Bidding and Contract Requirements
Addendum No. 1

Date: June 2, 2021
To: Plan Holders
Subject: Addendum No. 1 to the Bidding Documents for: ITB No. 2021-003

Satellite Jail HVAC Replacement Project
502 South Lierman Avenue
Urbana, Illinois

SHEET:
A-103

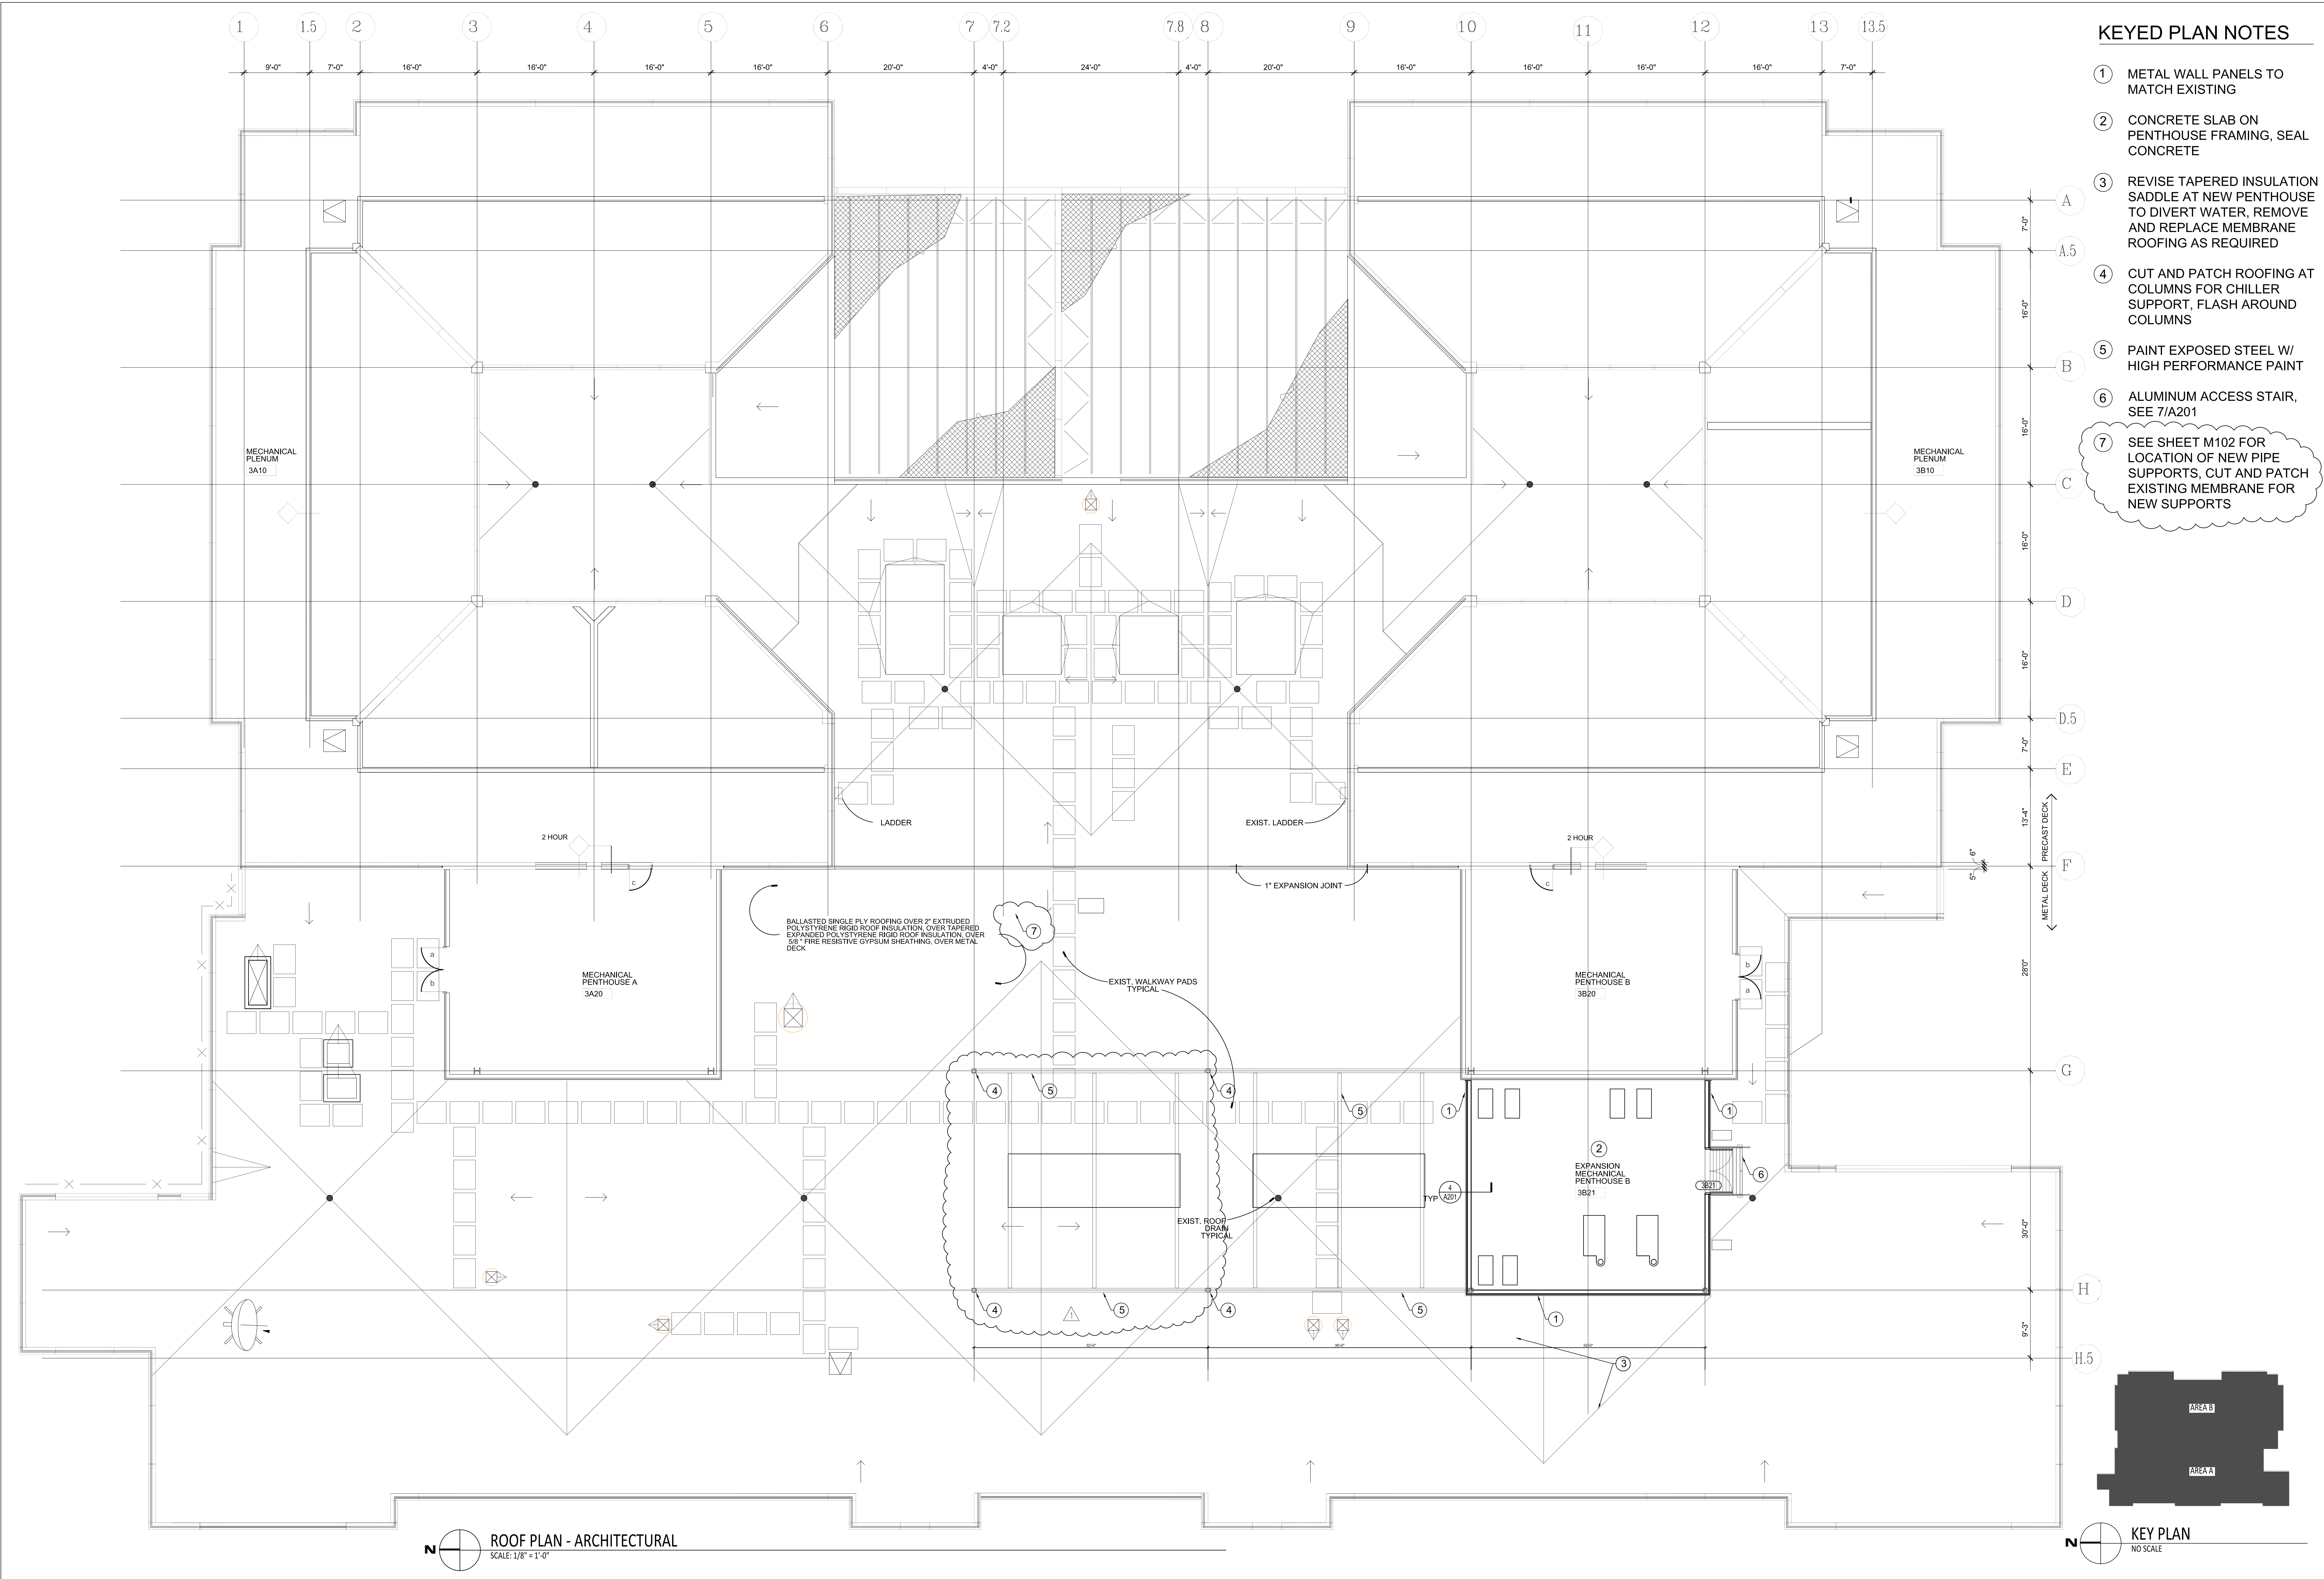
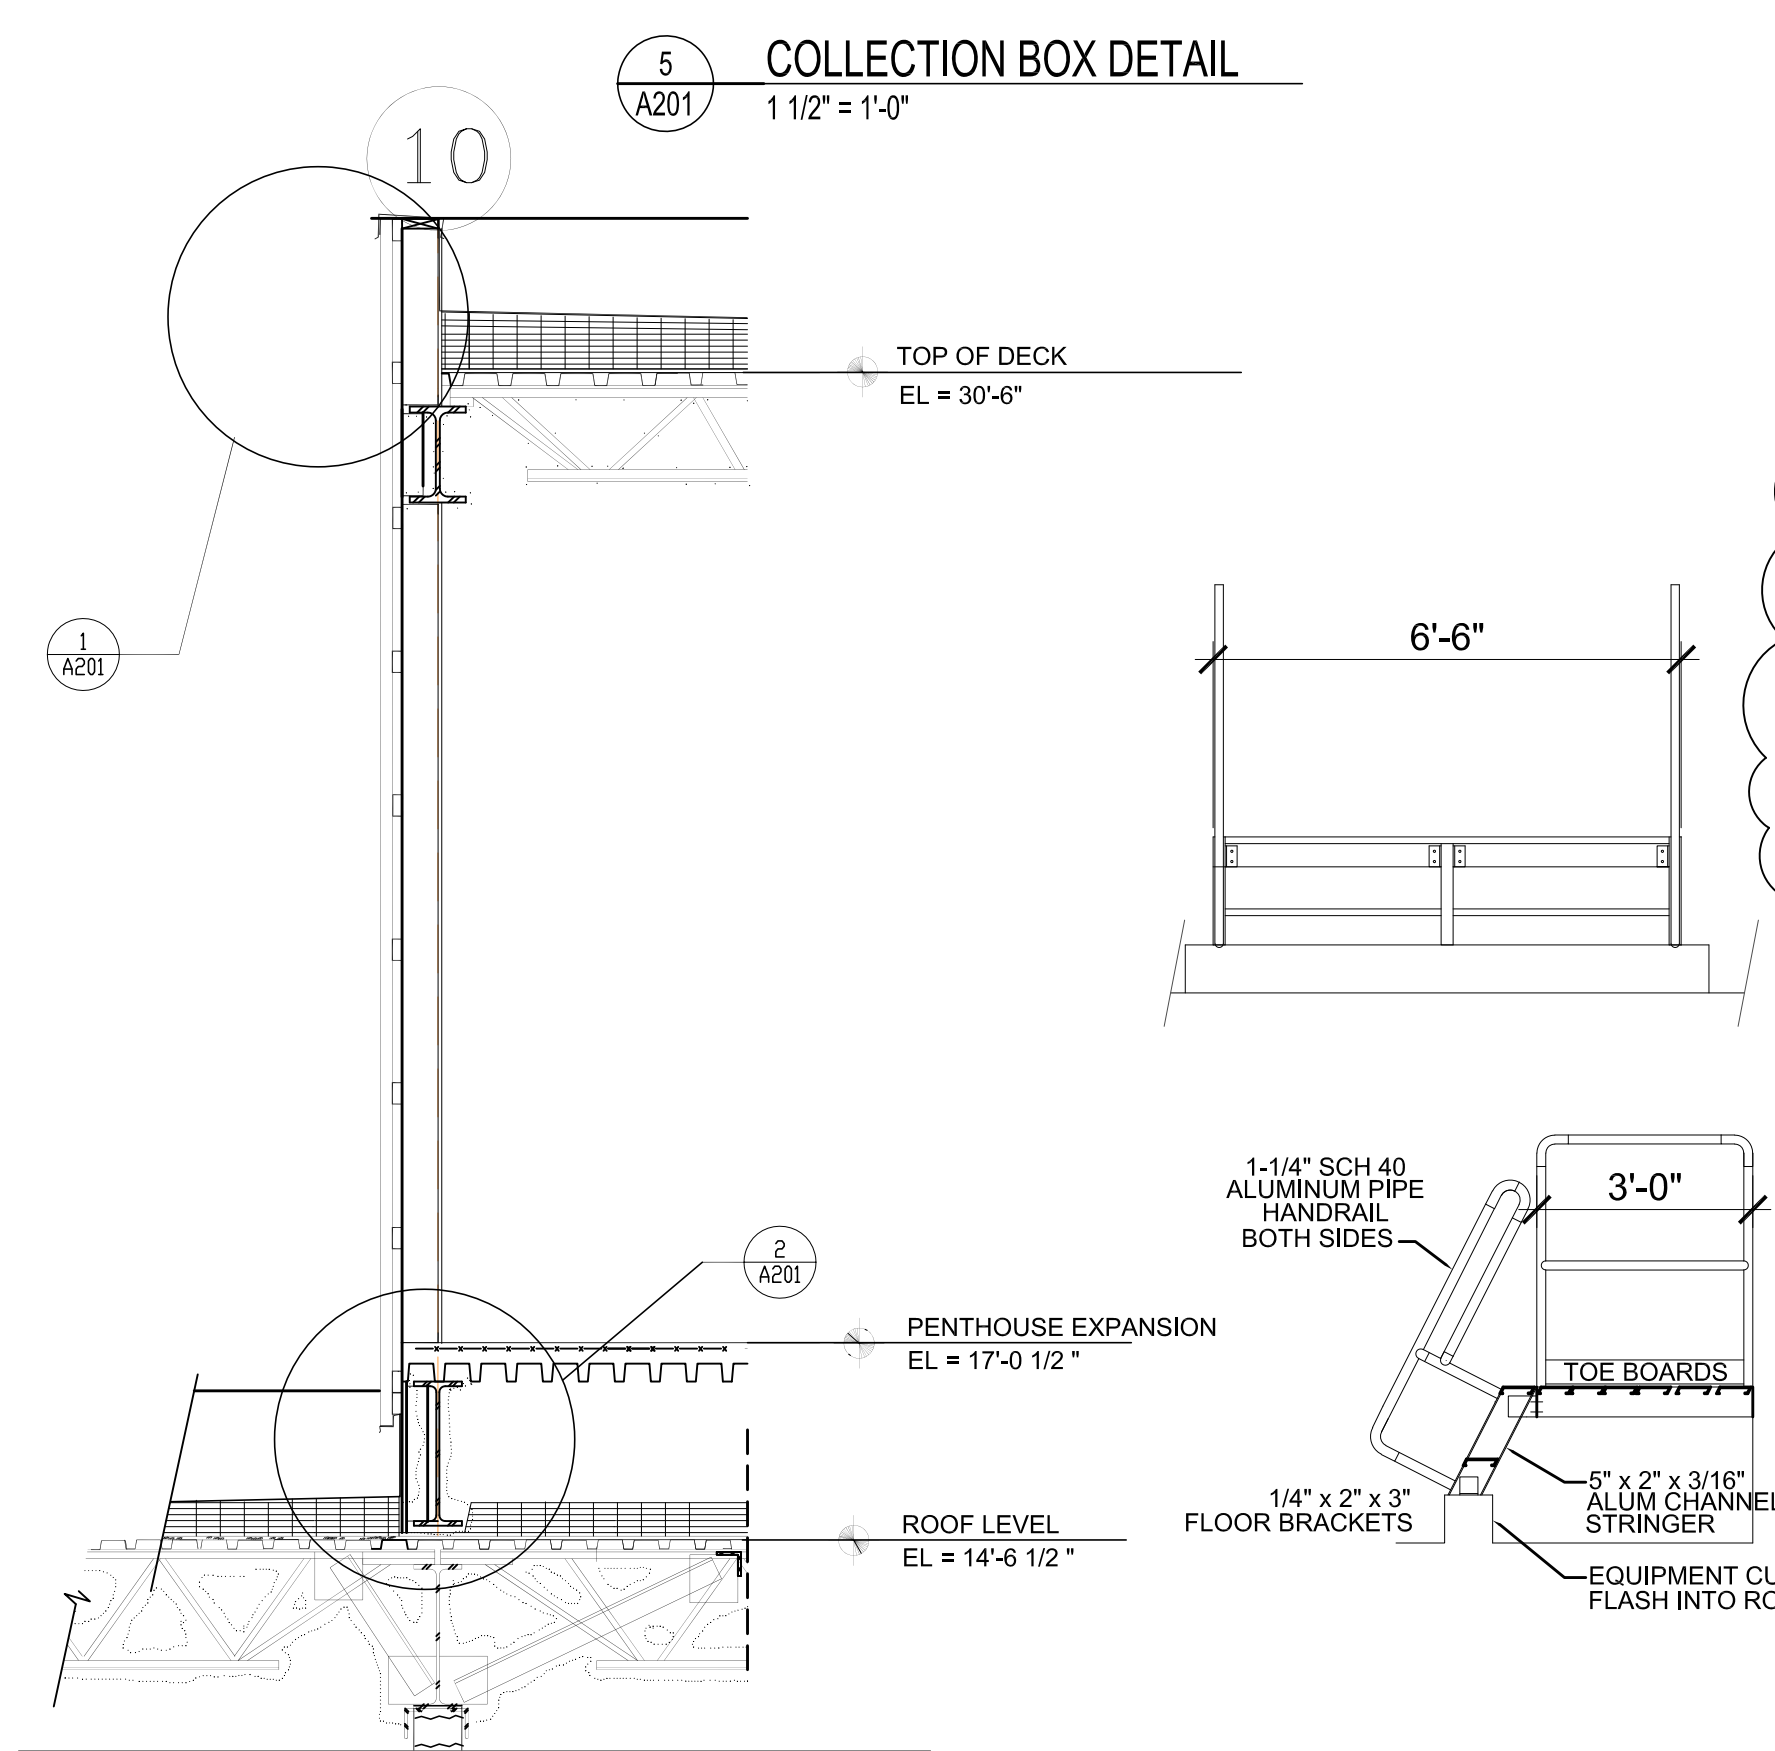
1. Sheet A103 - ROOF PLAN - ARCHITECTURAL
 - a. REVISE structural layout as shown. See attached sheet.
 - b. ADD roofing cut and patch note. See attached sheet.
2. Sheet A201 - ROOF PLAN - DEMOLITION / DETAILS
 - a. ADD penthouse steel fireproofing note. See attached sheet
 - b. ADD roofing note for column installation. See attached sheet.
3. Sheet M-102 - SECOND FLOOR PLAN - AREA B - HVAC
 - a. REVISE piping sizes. See attached sheet.
 - b. ADD note for rerouting of existing plumbing vent. See attached sheet.

- 1 METAL WALL PANELS TO MATCH EXISTING
- 2 CONCRETE SLAB ON PENTHOUSE FRAMING, SEAL CONCRETE
- 3 REVISE TAPERED INSULATION SADDLE AT NEW PENTHOUSE TO DIVERT WATER, REMOVE AND REPLACE MEMBRANE ROOFING AS REQUIRED
- 4 CUT AND PATCH ROOFING AT COLUMNS FOR CHILLER SUPPORT, FLASH AROUND COLUMNS
- 5 PAINT EXPOSED STEEL W/ HIGH PERFORMANCE PAINT
- 6 ALUMINUM ACCESS STAIR, SEE 7/A201
- 7 SEE SHEET M102 FOR LOCATION OF NEW PIPE SUPPORTS, CUT AND PATCH EXISTING MEMBRANE FOR NEW SUPPORTS
